SUBJECT: Mecklenburg County, Replace Bridge No.36 on SR 3135 over Irvins Creek;
T.I.P. Number B-3677; Federal Aid Project No. BRSTP-3135(4); State Project
8.2674104

SUBJECT: **Notice of Permit Modification for Nationwide Permit 13** for the proposed replacement of Bridge No. 36 over Irvins Creek on SR 3135. Mecklenburg County, Federal Project No. BRSTP-3135(4), Division 10, T.I.P. No. B-3677, WBS Element 33172.1.1.

Please see the enclosed revised permit drawings for the above referenced project. A Nationwide Permit 13 Notice of Use letter was issued by NCDOT on March 31, 2008 for 91 feet of permanent fill in the Irvins Creek. A recent change in the design for this project includes the building a three span bridge instead of a single span bridge. There will be an additional 9 feet of permanent stream from the placement of riprap on the banks of Irvins Creek for bank stabilization for a total of 99 feet.

Permit Drawing
 Sheet 5 of 7
 Revised March 2009

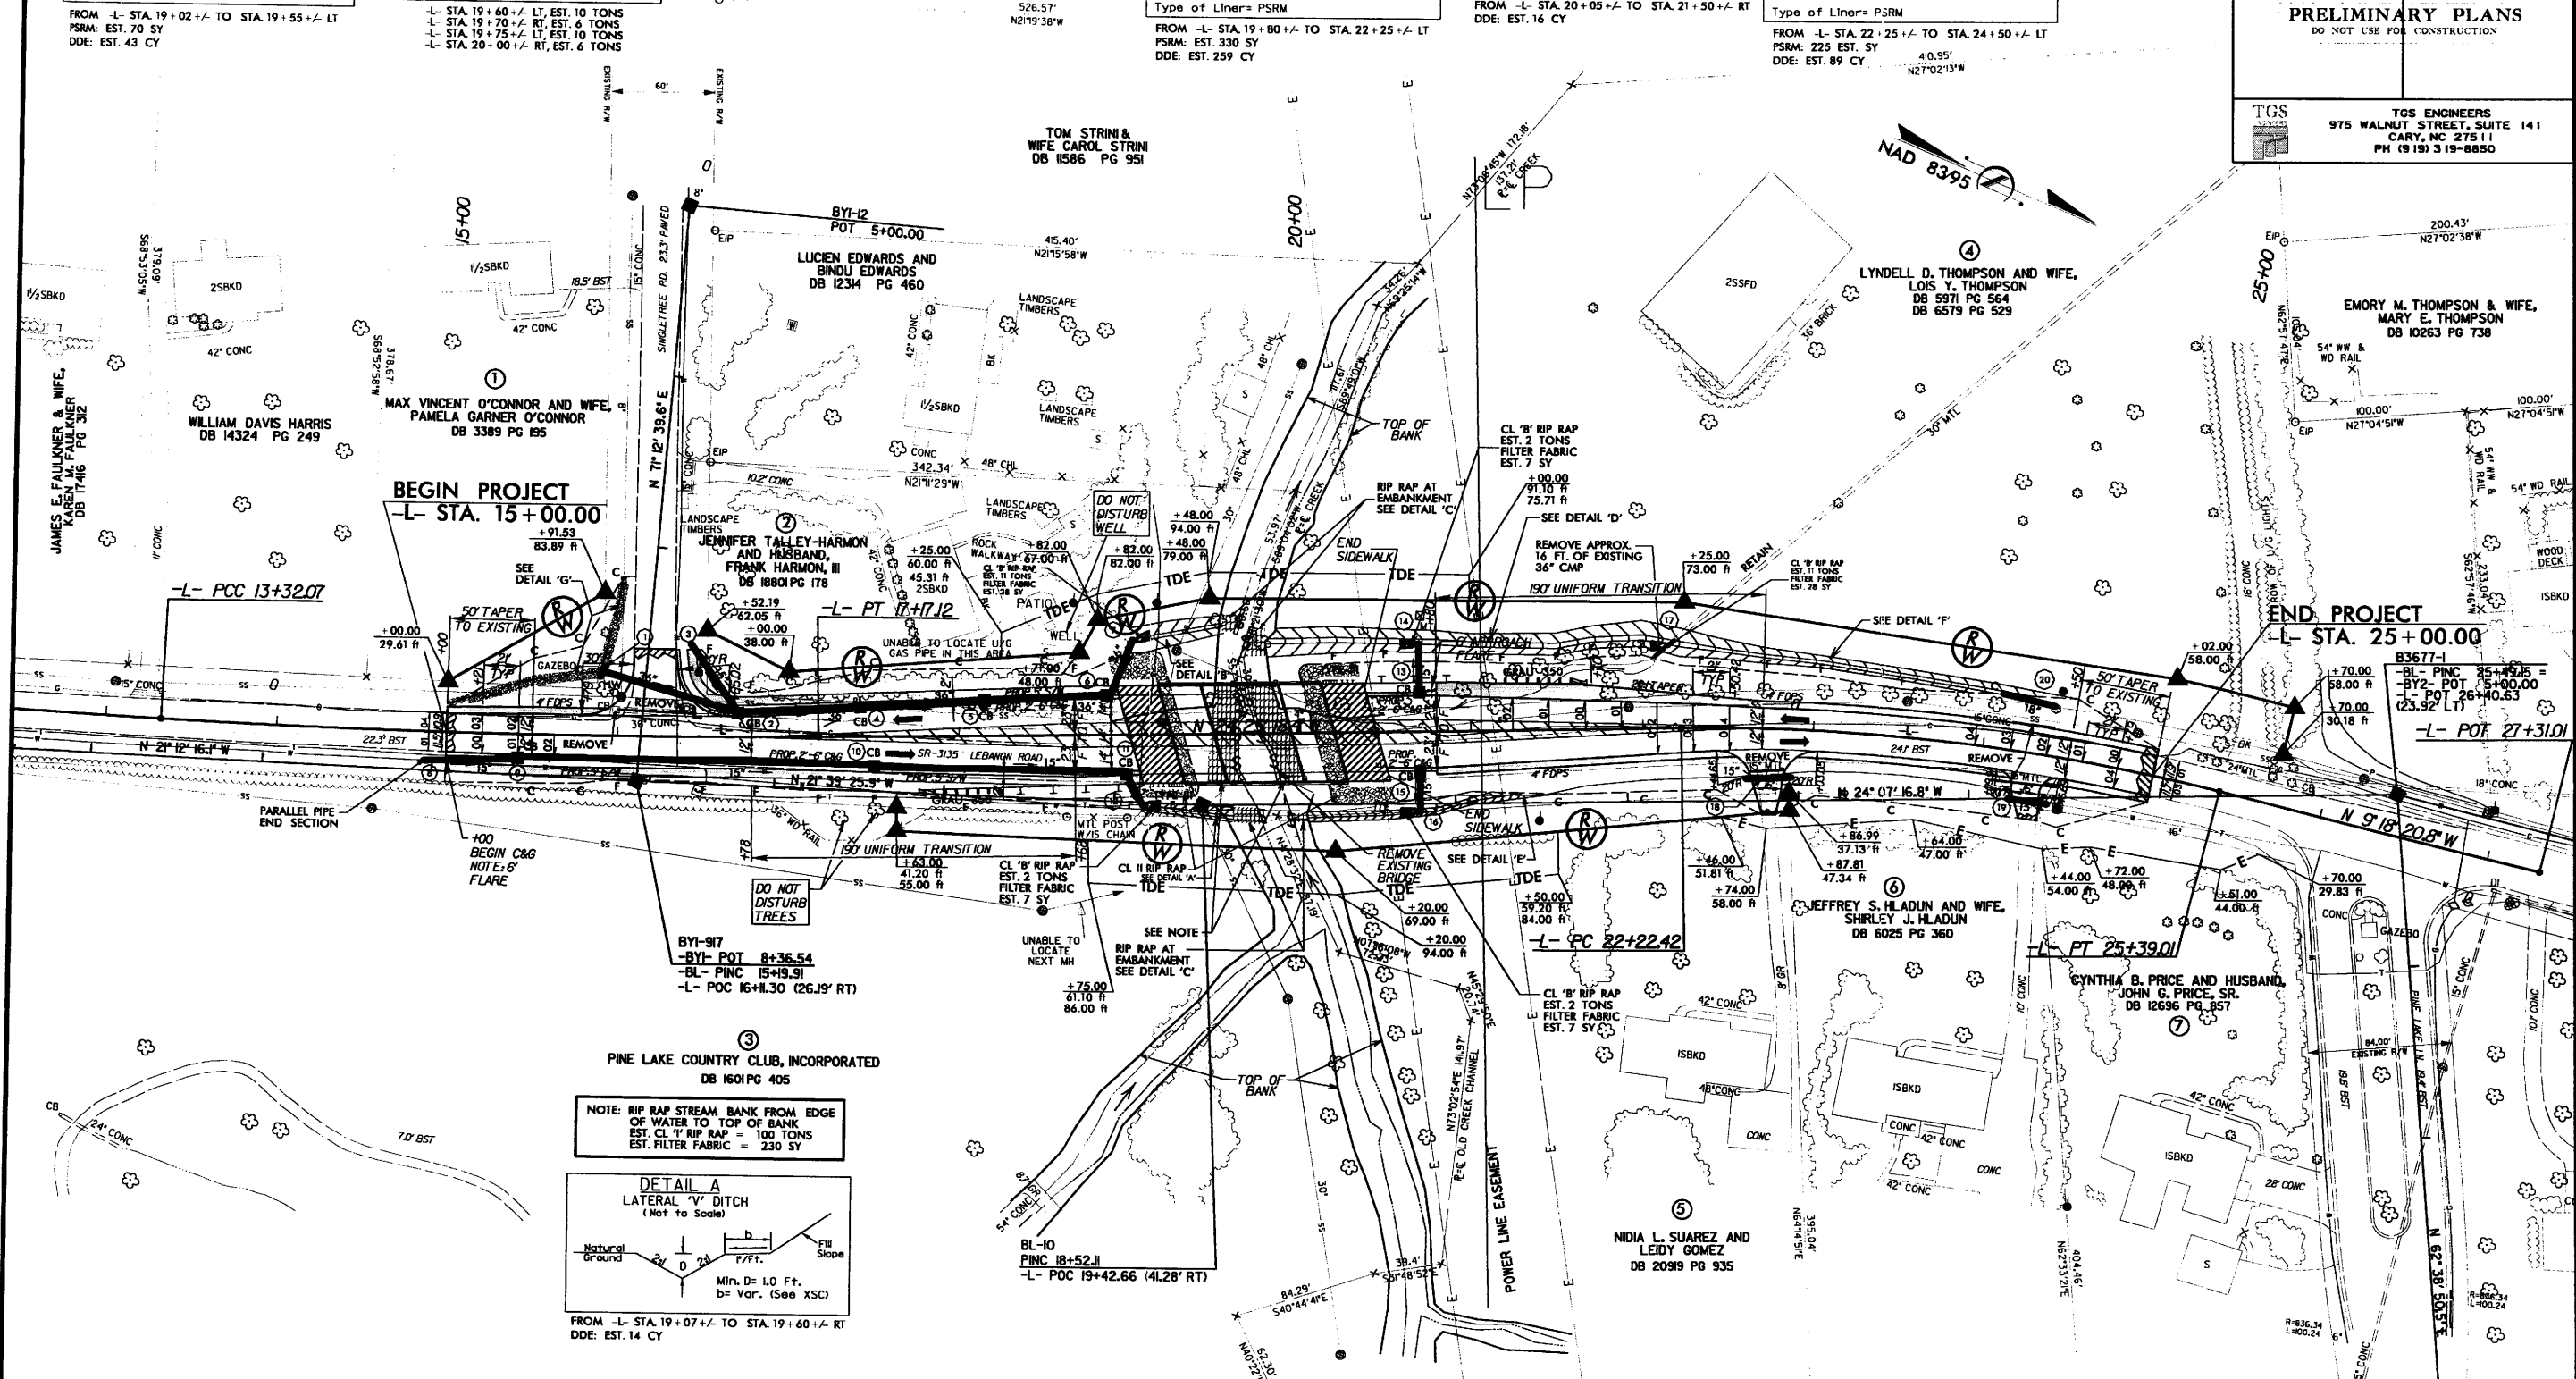
REVISIONS
 - REMOVED PROPOSED RW & REVISED DRIVEWAY ON PARCEL 6. REPLACED DRIVE PIPE ON PARCEL 4. REVISED OWNER NAMES ON PARCELS 2, 5, & 7. WC PARKER, PE
 - REVISED OWNER NAMES ON FOUR PARCELS OUTSIDE OF PROJECT LIMITS; ADDED OFFSETS TO RW & EASEMENT FLAGS AT VARIOUS POINTS ALONG PROJECT. WC PARKER, PE

NOTE: RIP RAP STREAM BANK FROM EDGE OF WATER TO TOP OF BANK
 EST. CL 'V' RIP RAP = 100 TONS
 EST. FILTER FABRIC = 230 SY

Permit Drawing
Sheet 6 of 7
Revised March
2009

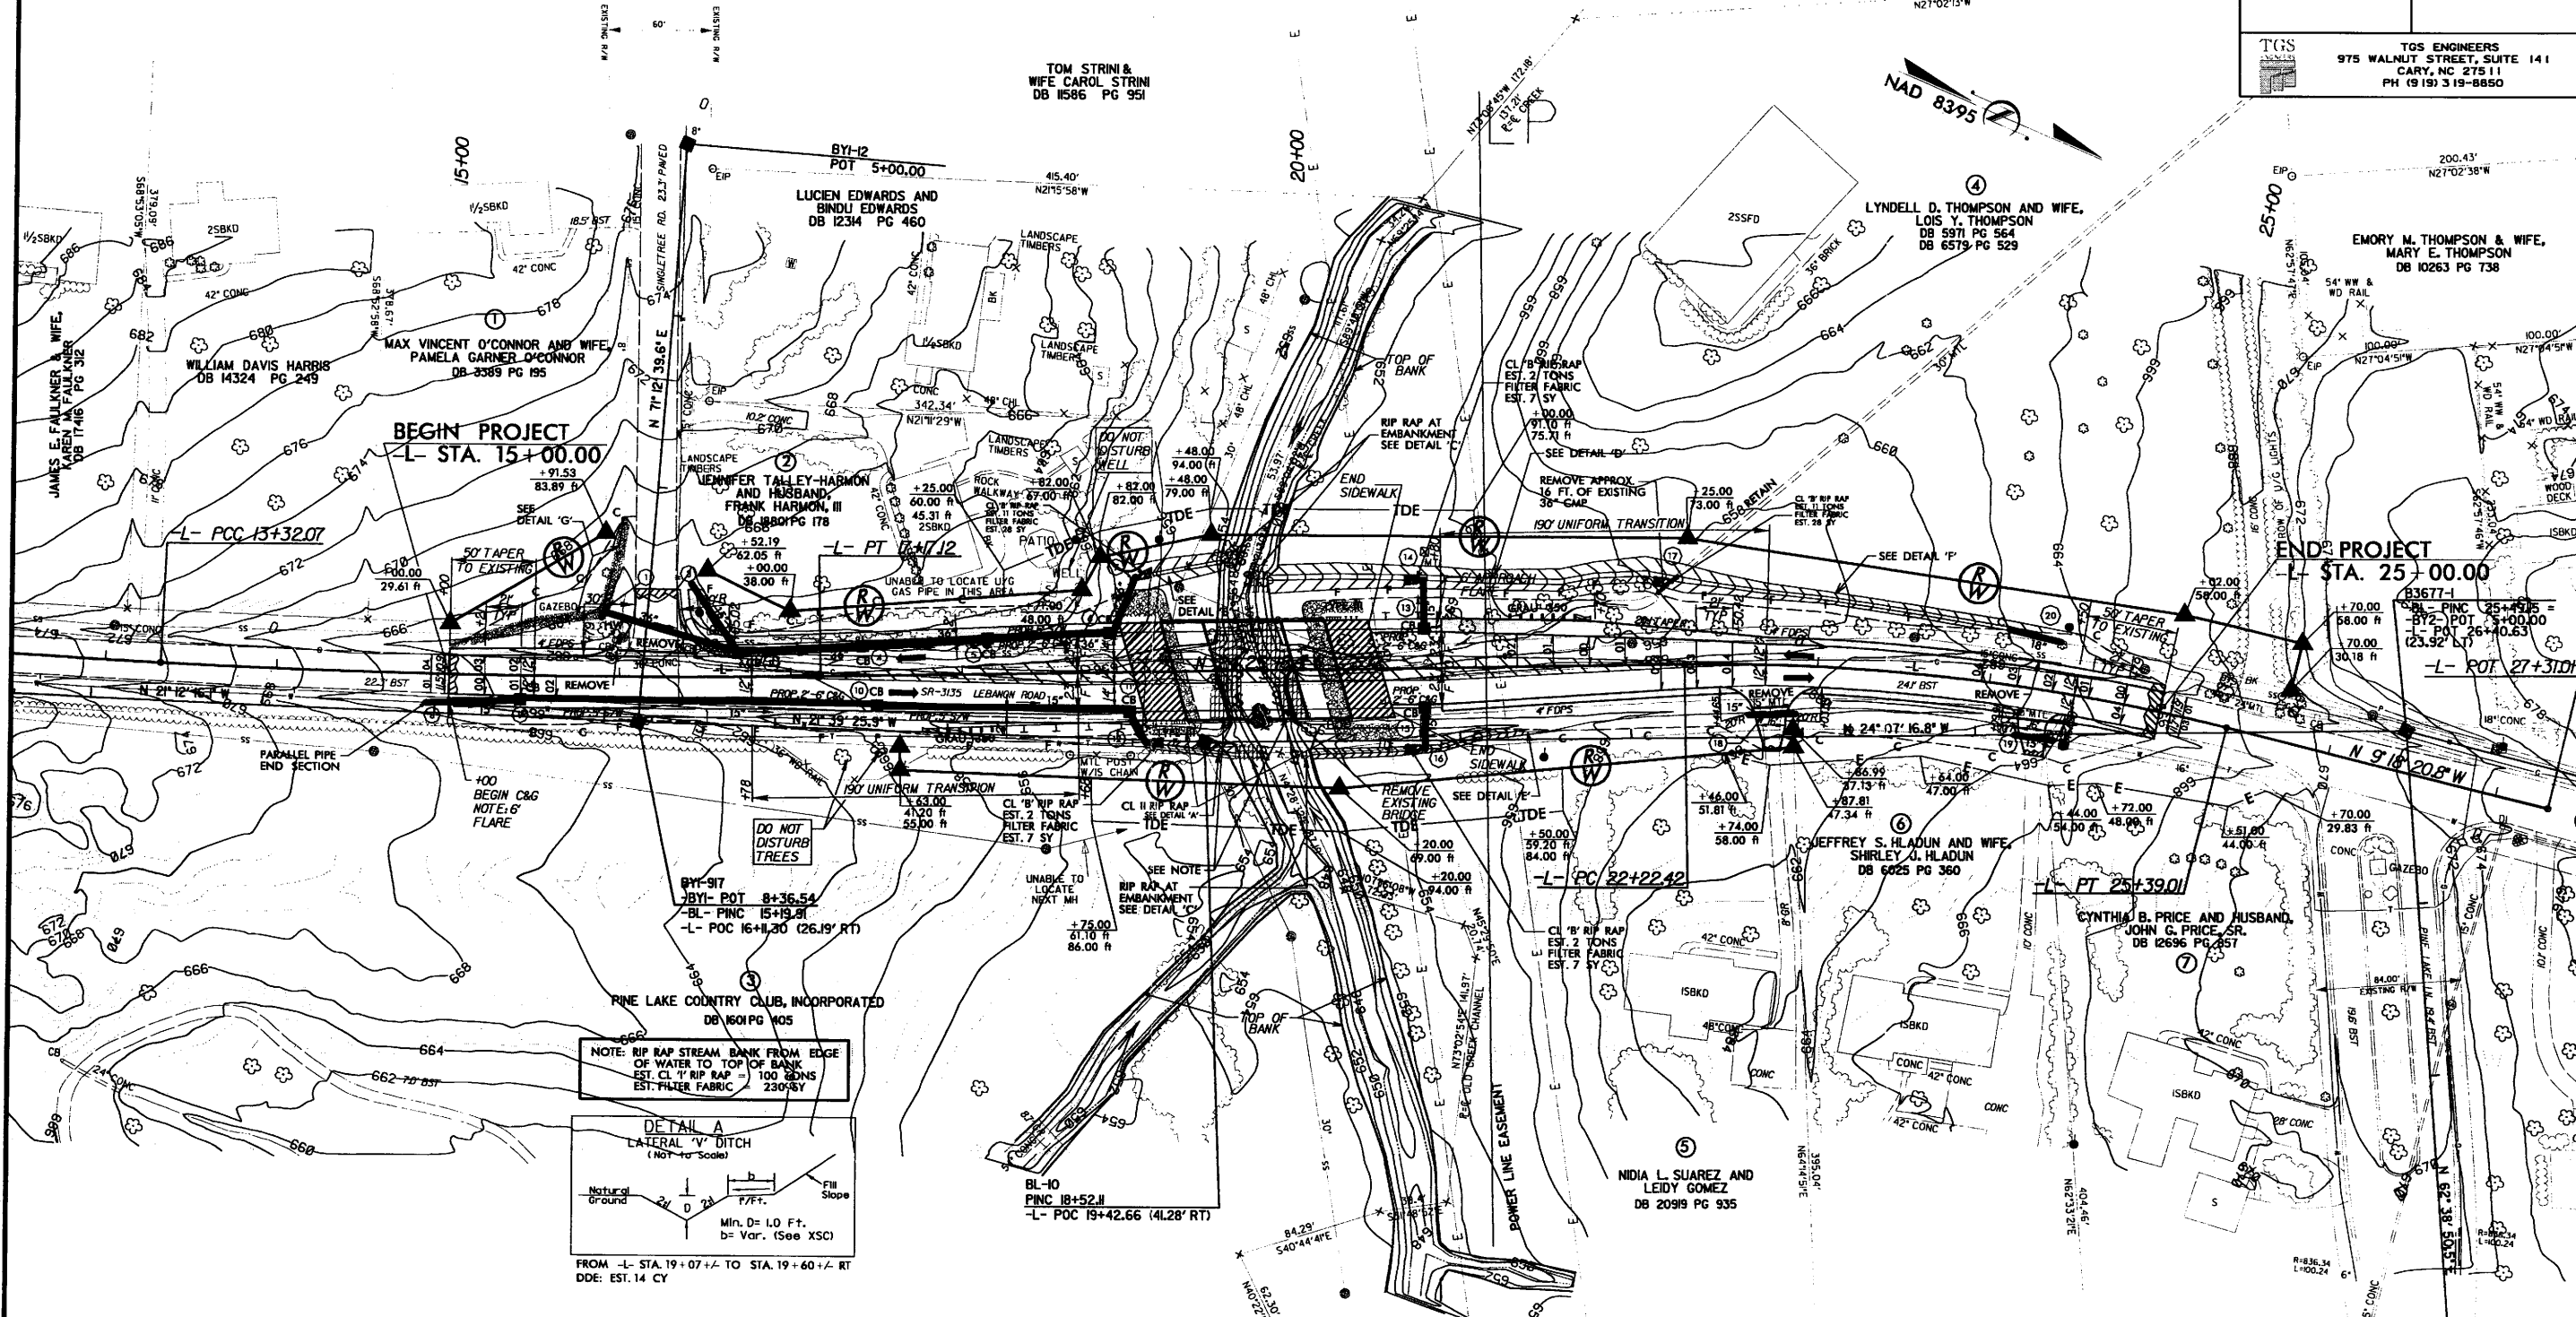
REVISIONS
 - REMOVED PROPOSED RW & REVISED DRIVEWAY ON PARCEL 6 & REPLACED DRIVE PIPE ON PARCELS 2, 5, & 7. WC PARKER, PE
 - REVISED OWNER NAMES ON FOUR PARCELS OUTSIDE OF PROJECT LIMITS; ADDED OFFSETS TO RW & EASEMENT FLAGS AT VARIOUS POINTS ALONG PROJECT. WC PARKER, PE
 DATE: _____
 DATE: _____

Type of Liner= CL 'B' Rip-Rap
FROM -L- STA. 15+00.00 TO STA. 15+90+/- LT
CLASS 'B' RIP RAP: EST. 48 TONS
FILTER FABRIC: EST. 65 SY

SEE PLANS RT SIDE OF SR4141 (15.7% SLOPE)
CLASS 'B' RIP RAP: EST. 30 TONS
FILTER FABRIC: EST. 43 SY
